Renfrew
Bridging Charm and Convenience

Addendum No. 1

Project No. 2025-10-LCRS

Project: Ma-te-way Park Power Supplies - Phase 1

DESIGNED BY: P.SCISSONS	PROJECT No.: 25-4029A
DRAWN BY: P.SCISSONS	ISSUE DATE: 08/20/2025
CHECKED BY: R.KONG	ISSUED FOR: ADD-01
APPROVED BY: R.KONG	SHEET No.: SKE-201.1

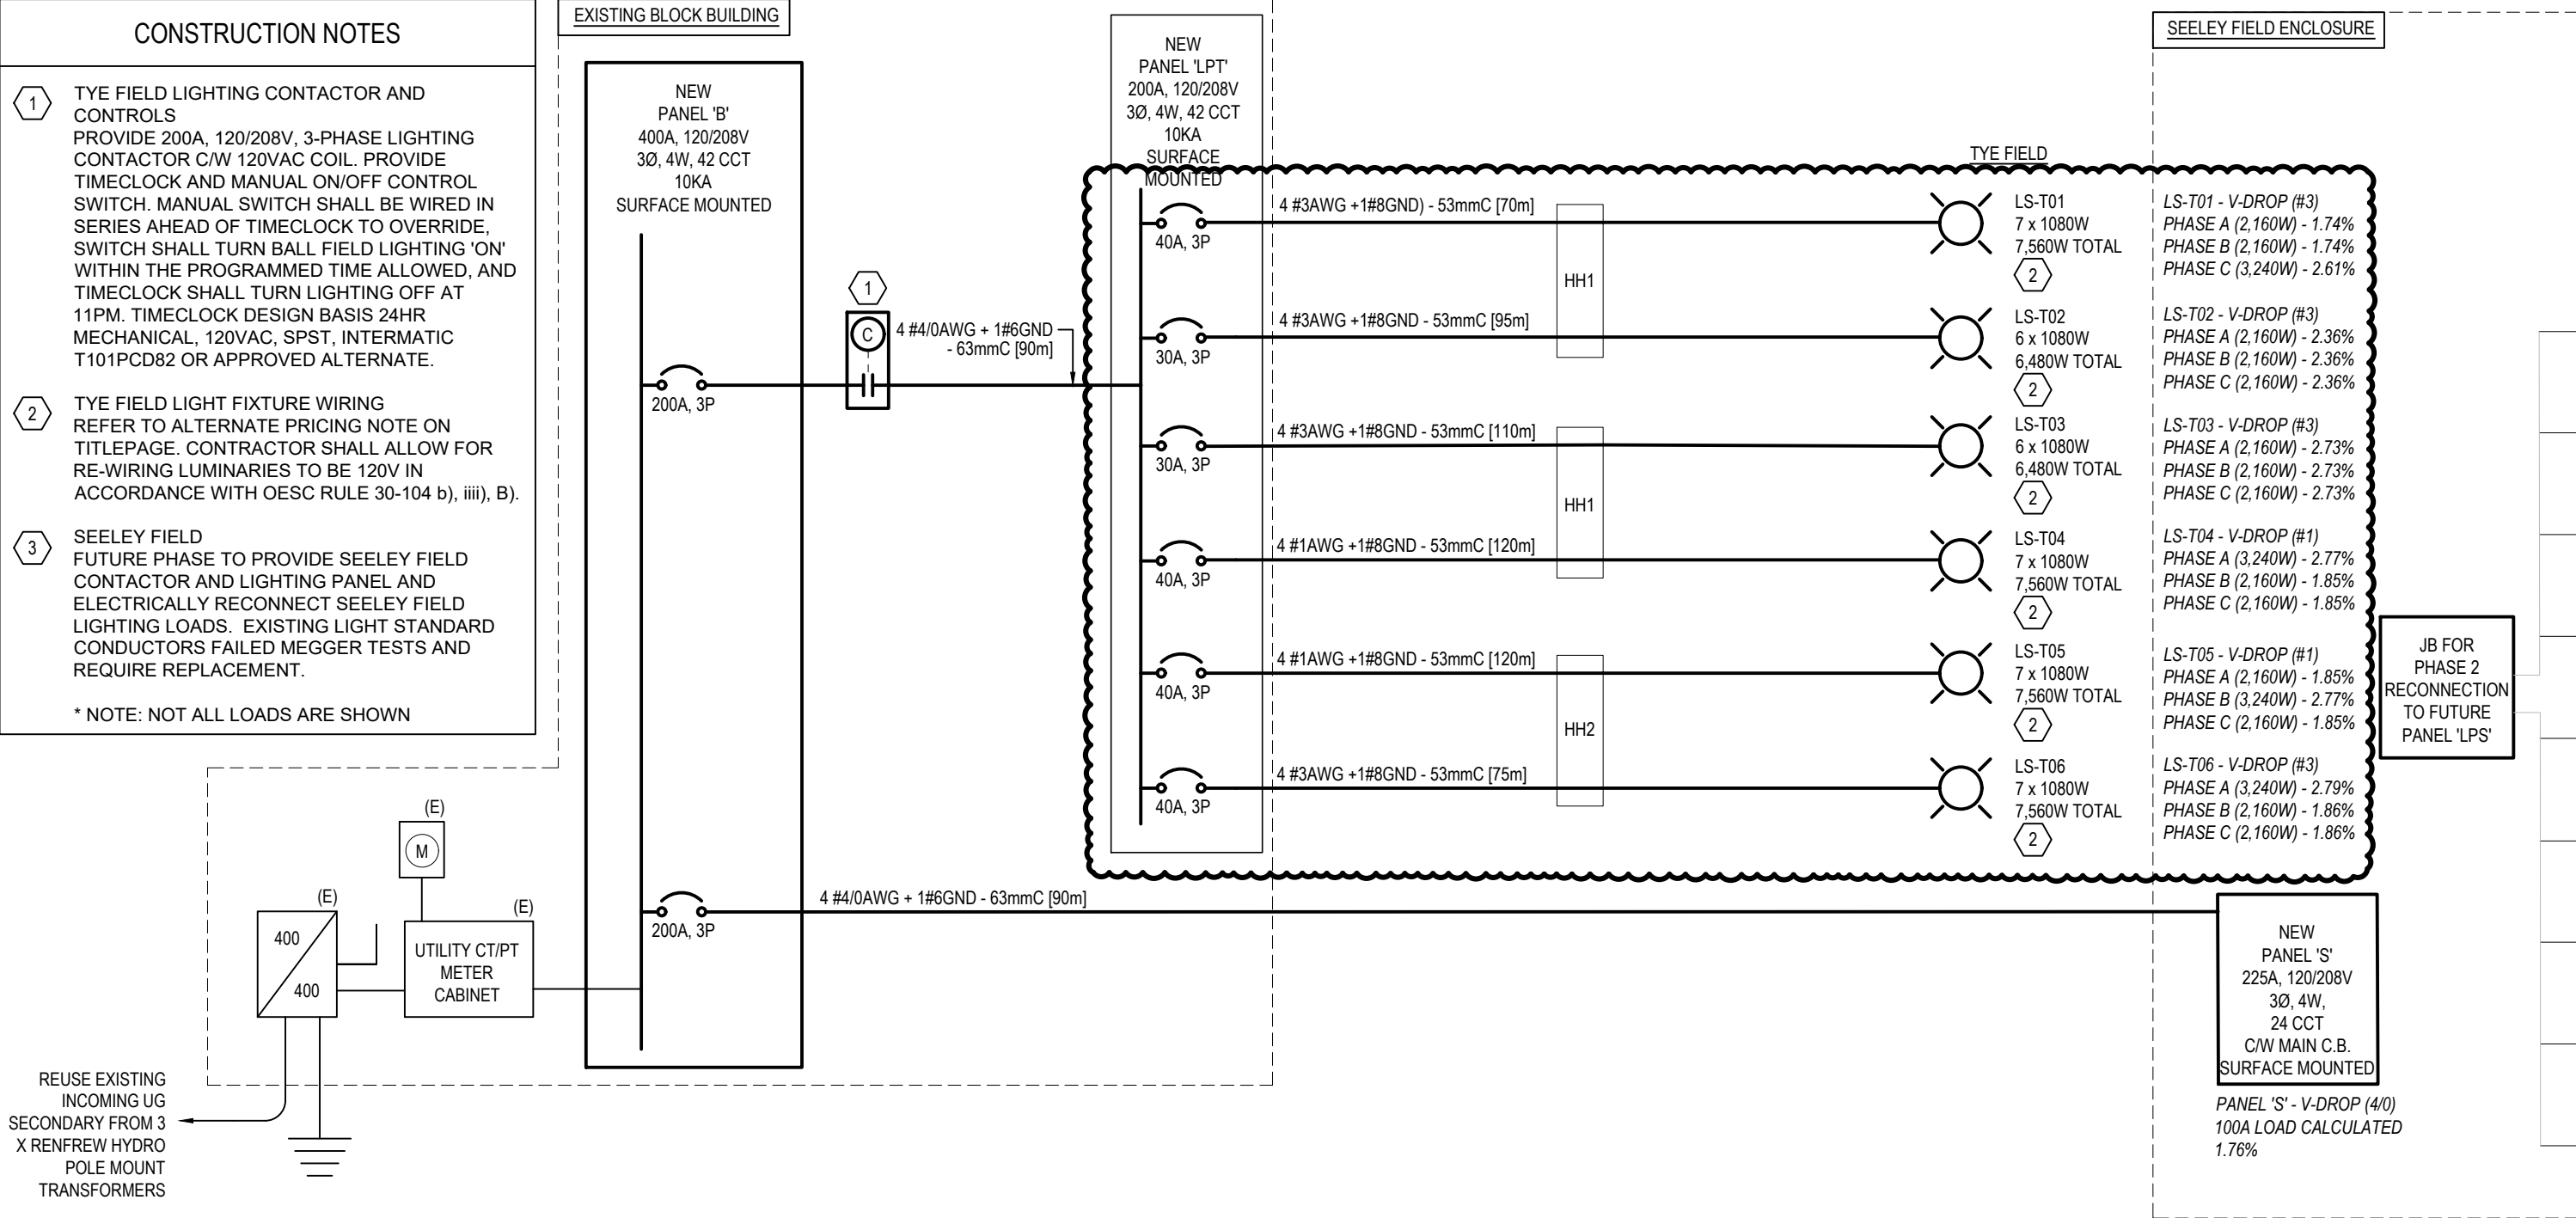
1. **Question:** Can we confirm that the wire size is large enough for the branch circuit wiring (3% voltage drop) to all the fixtures. Example LS-T05. 1 of 3 circuits will have 27amps on it at 120v 460ft I get 1awg copper.

- 2. Question:** Panel LPT shows 30amp 3p breakers. There are 4 light standards that one circuit will have 27amp load on it. Assuming the light will be on longer than 3 hours (continuous load) A 40amp breaker will be required. A continuous load (expected to run 3 hours or more) cannot exceed 80% of the breaker rating.

See attached SKE-201.1 single line new work showing updated conductor size and conduit quantity.

Revise duct bank quantity to route dedicated 53mm (2") to each light standard. Provide new in-line fuses and terminations in existing pole handhole.

Answer: Refer to attached sketch SKE-201.1 single line diagram new work. Revise four (4) circuit breakers in Panel LPT from 30A,3P to 40A,3P (feed light standards with 7 fixtures).
